**DESIGN REVIEW BOARD AGENDA
NOTICE OF MEETING**

TITLE: <p style="text-align: center;">DESIGN REVIEW FILE: DESIGN-2023-30-OCTOBER-6A 19 RICHMOND STREET (PID #339739) OWNER: 103040 PEI INC. (JACKIE AND PHILIP O'HALLORAN)</p>		
MEETING DATE: October 30, 2023		Page 1 of 5
DEPARTMENT: Planning & Heritage	ATTACHMENTS: <ul style="list-style-type: none"> A. Design Review Original Submission (June 27, 2023) B. External Design Reviewer Comments (August 8, 2023) C. Revised Design Reviewer Submission (September 12, 2023) D. Final Design Submission (October 24, 2023) 	
SITE INFORMATION: Ward No: 1 Queens Square Existing Land Use: Vacant lot previously occupied by Irwin Printing Official Plan: Downtown Neighbourhood Zoning: Downtown Neighbourhood Zone (DN)

TITLE: DESIGN REVIEW FILE: DESIGN-2023-30-OCTOBER-6B 199 GRAFTON STREET/156 PRINCE STREET (PID #342790) OWNER: 102390 PEI INC. APPLICANT: APM COMMERCIAL ROYAL LEPAGE		 CHARLOTTETOWN	
MEETING DATE: October 30, 2023		Page 1 of 7	
DEPARTMENT: Planning & Heritage		ATTACHMENTS: A. Design Review Submission Including Rationale Paper (August 25, 2023) B. External Design Reviewer Comments (October 26, 2023) C. Design Review Submission (February 21,

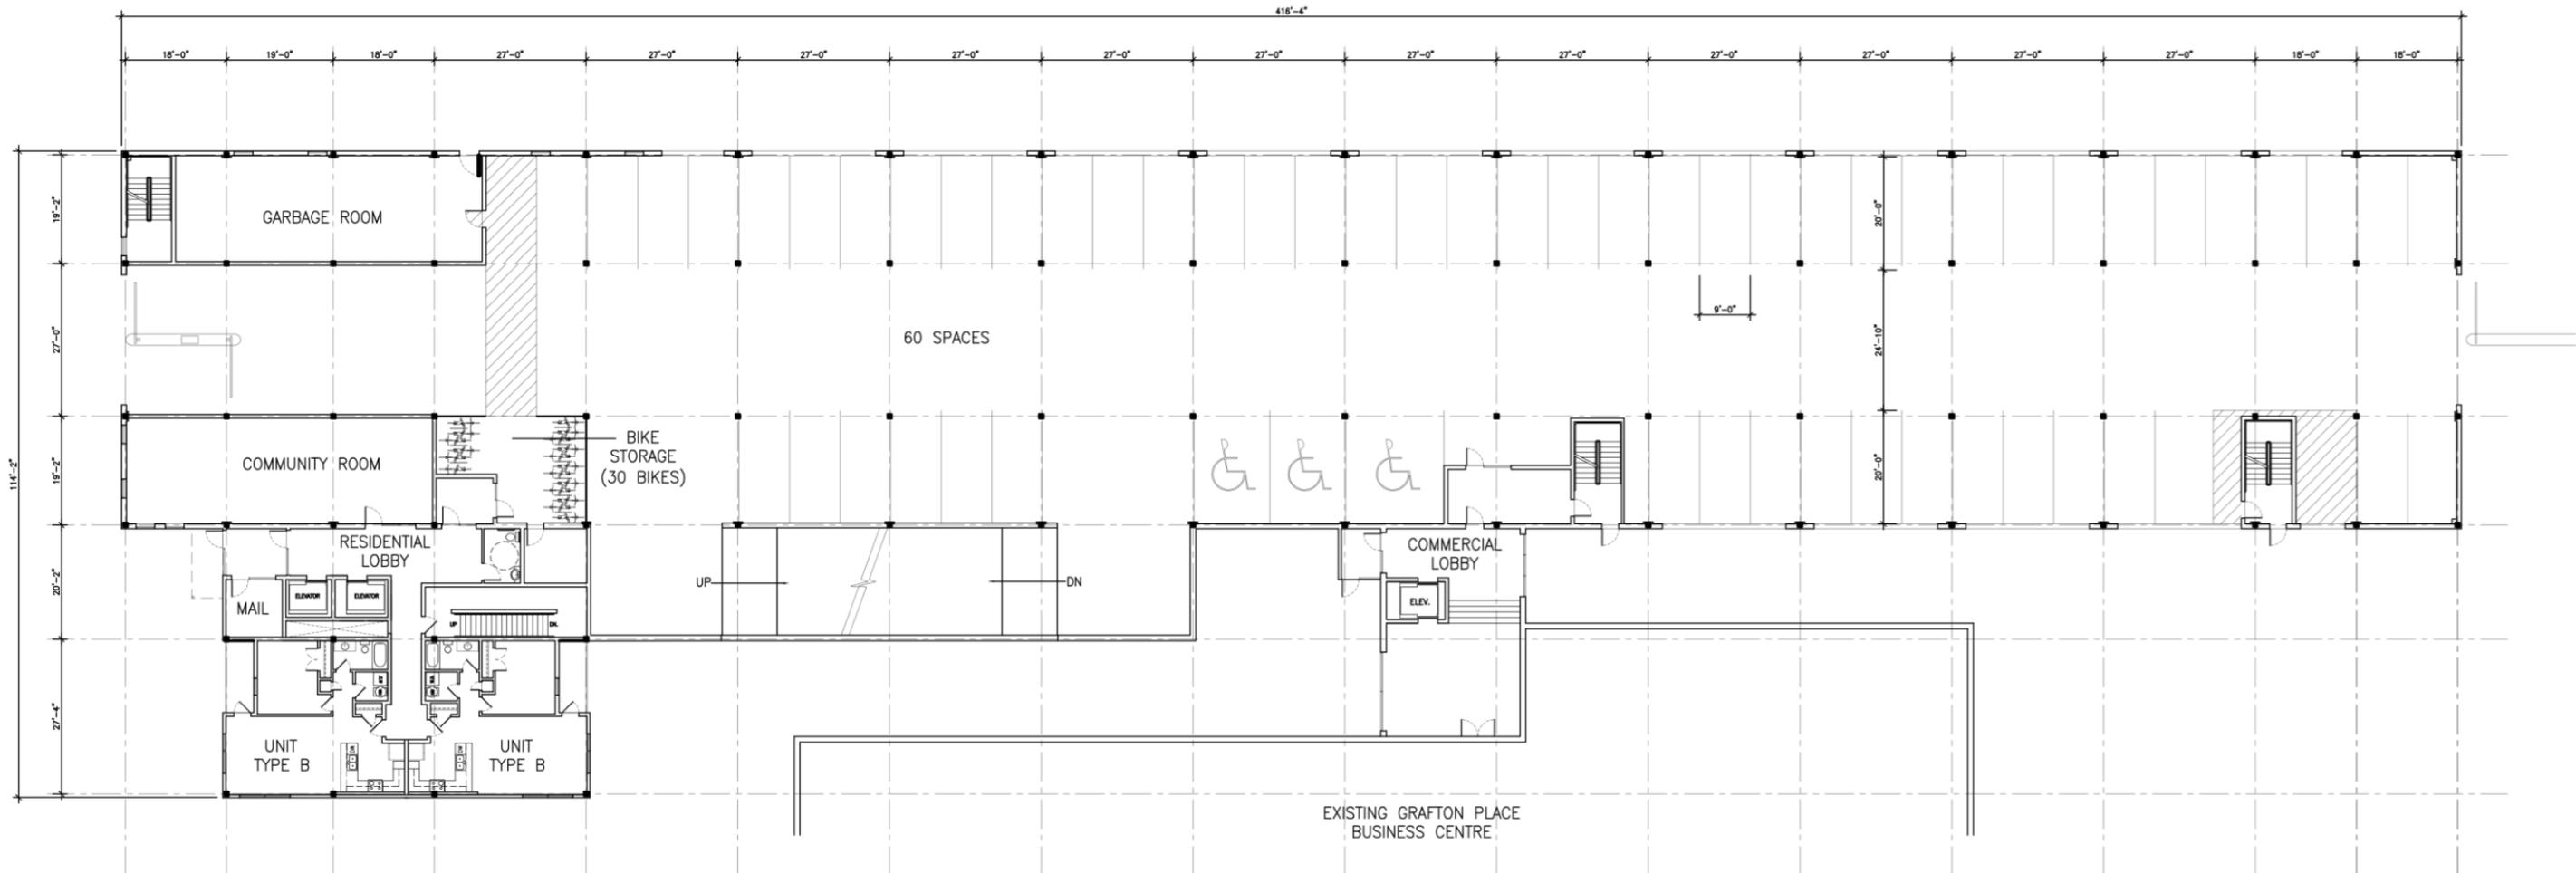
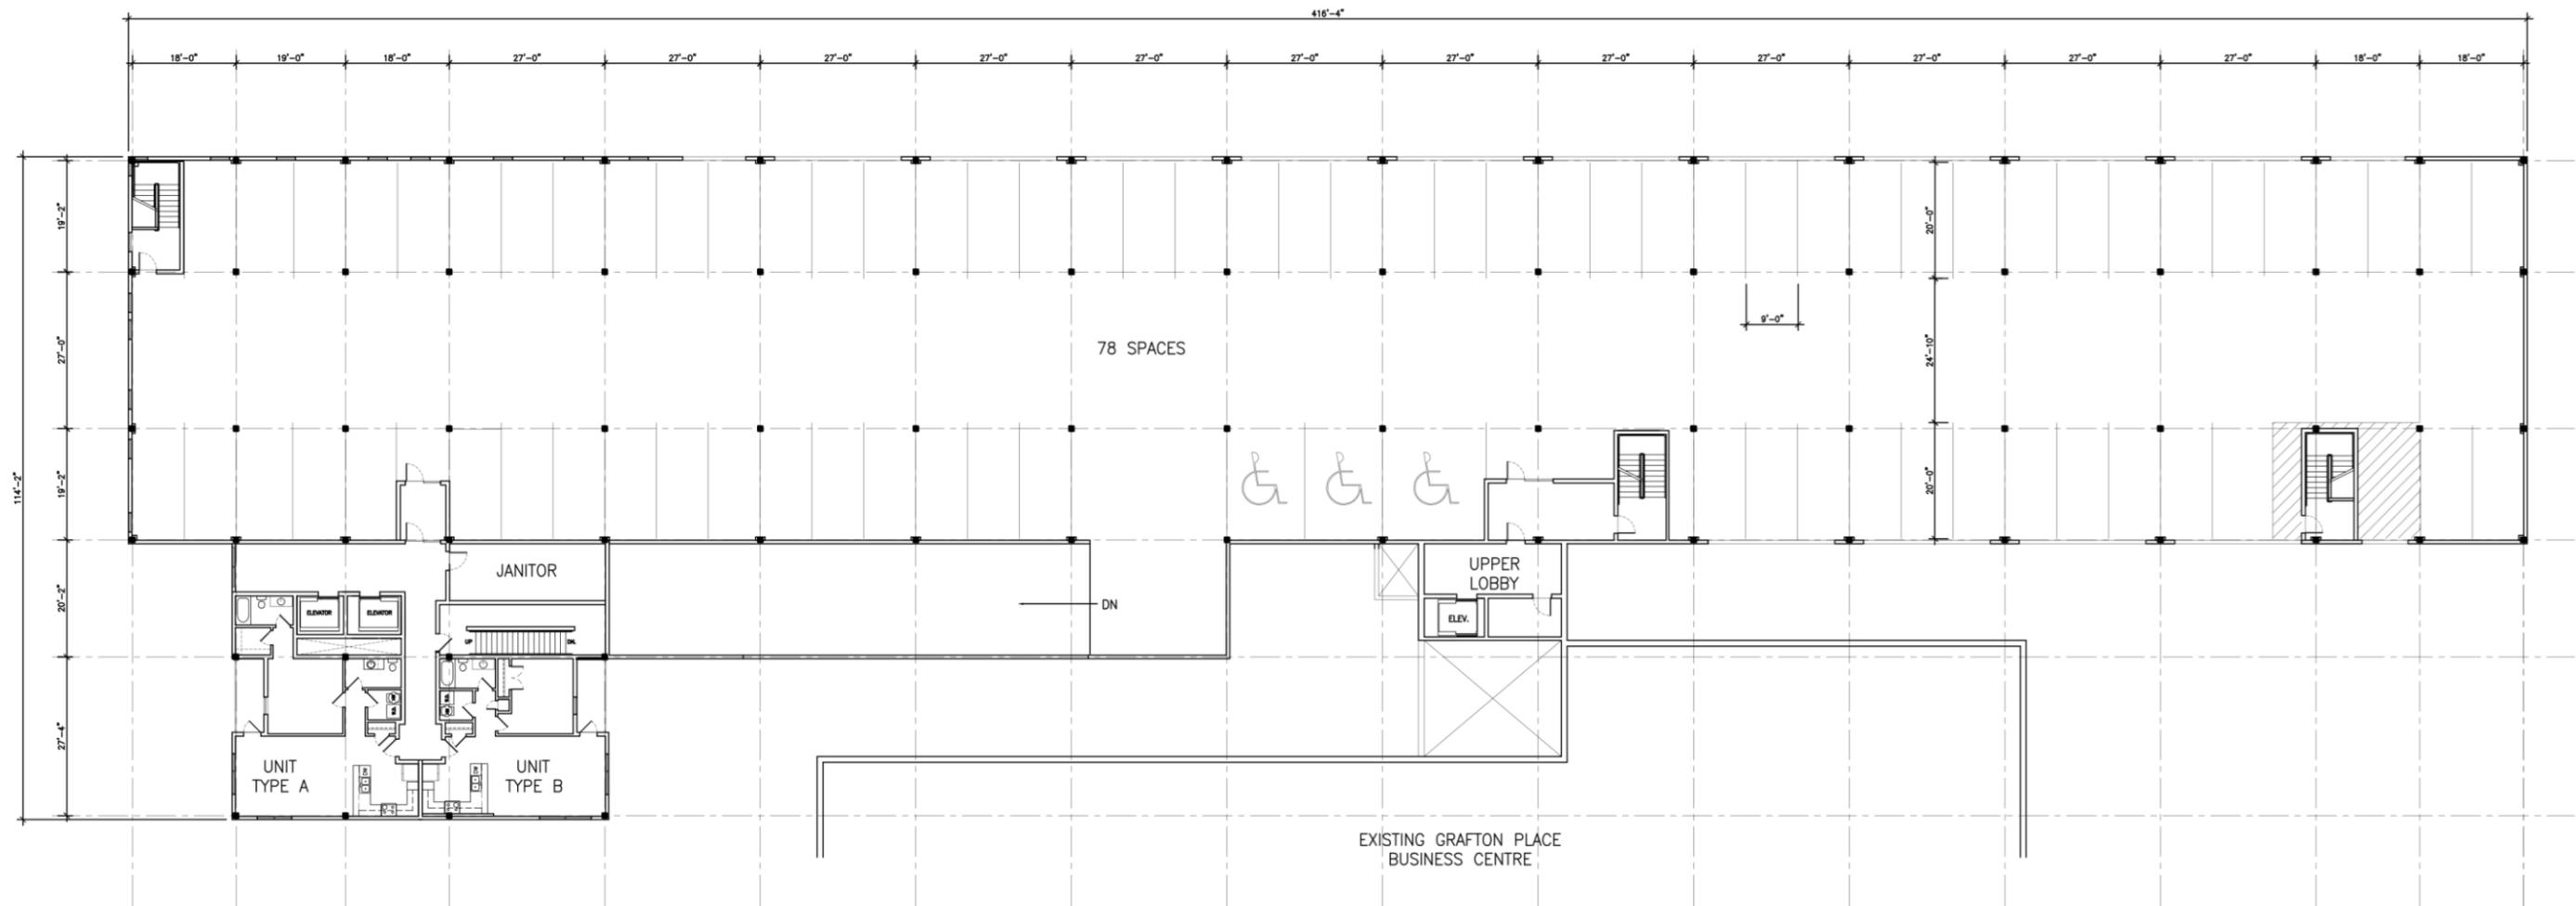
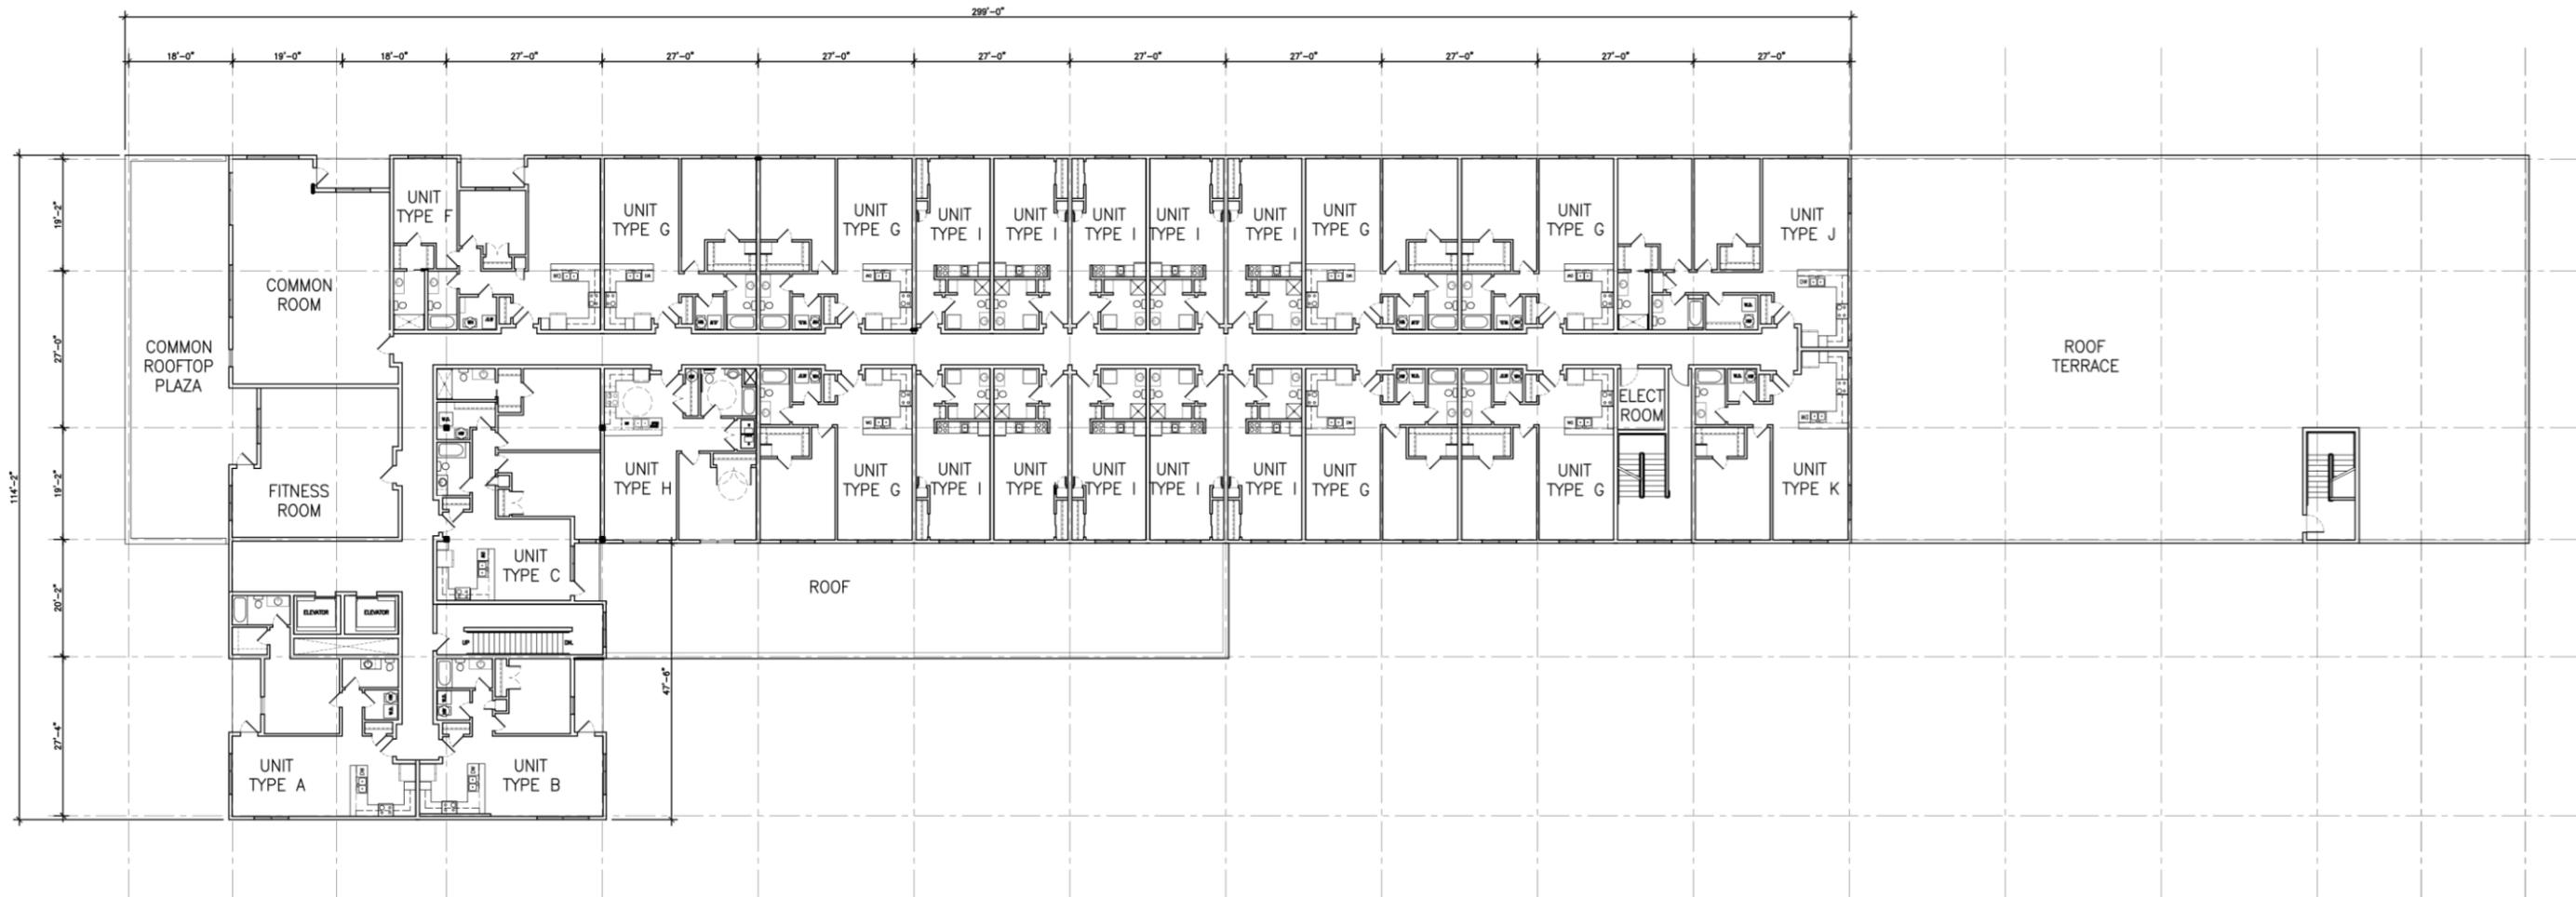
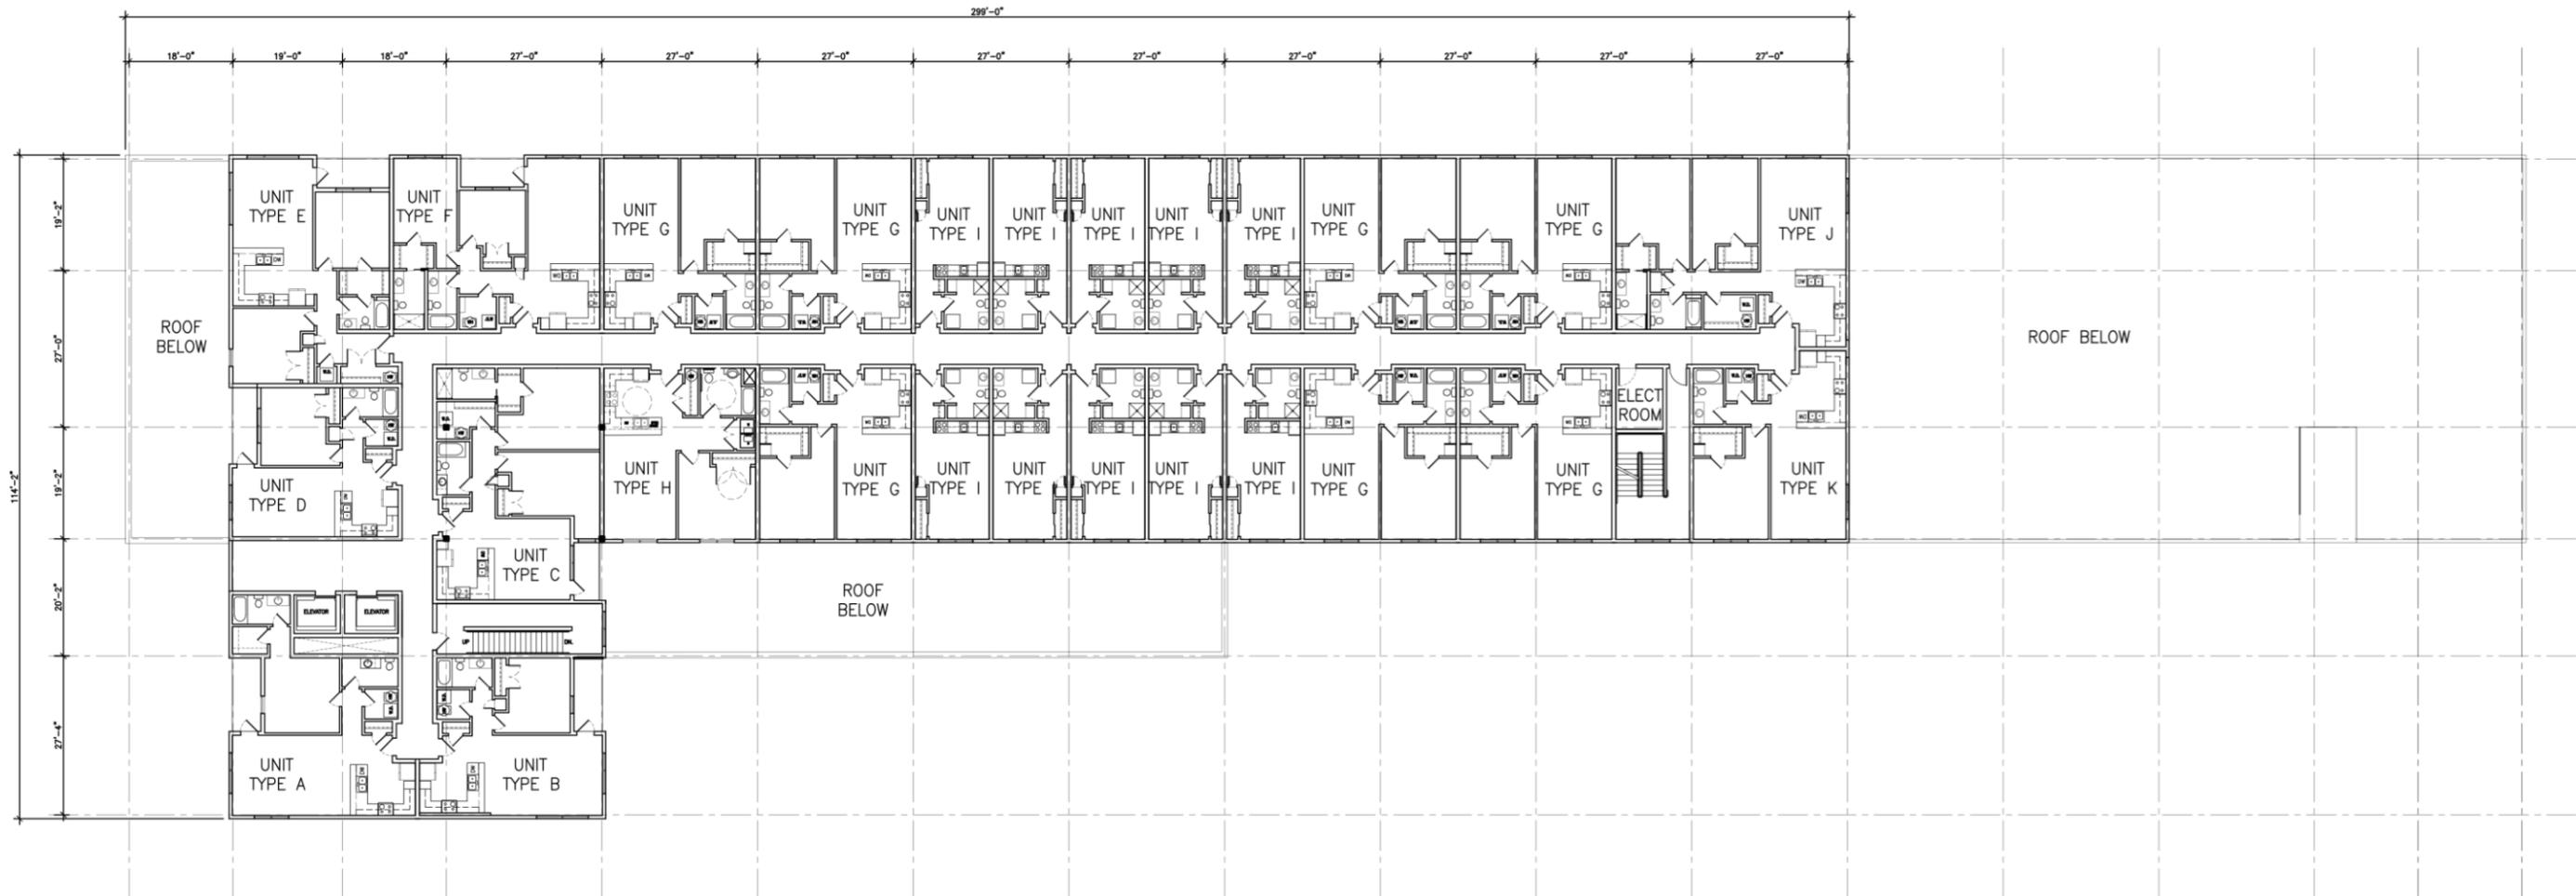
RECOMMENDATIONS: Two options to consider: 1. is recommended that the top two floors of the 8-storey proposal are stepped back to achieve the 45-degree angular plane bylaw. If this option is not desirable, then a variance will be required to override the Bonus Height Development Standards regarding the required 45-degree angular plane setback. 2. Extend the east end of the building closer to Hillsborough Street, to compensate for the units lost if the building were to stay six storeys, see image top of next page. The shaded area would potentially provide an equal number of units without going higher than six storeys.

In the design review report the design reviewer indicates that if the 7th and 8th floors are not stepped back to meet the 45-degree angular plane a variance will be required. The design reviewer's report was forwarded to the applicant for comment on the suggested changes and the applicant indicated that,

- *Prince Street elevation step backs...We feel this is an unnecessary hurdle with needless structural challenges and added costs, that also disrupts the current location of our elevators and diminishes the size and therefore rent of the upper premiere units along Prince Street. It's for these financial reasons, his recommendation to step the building back is something we are unable to compromise on.*
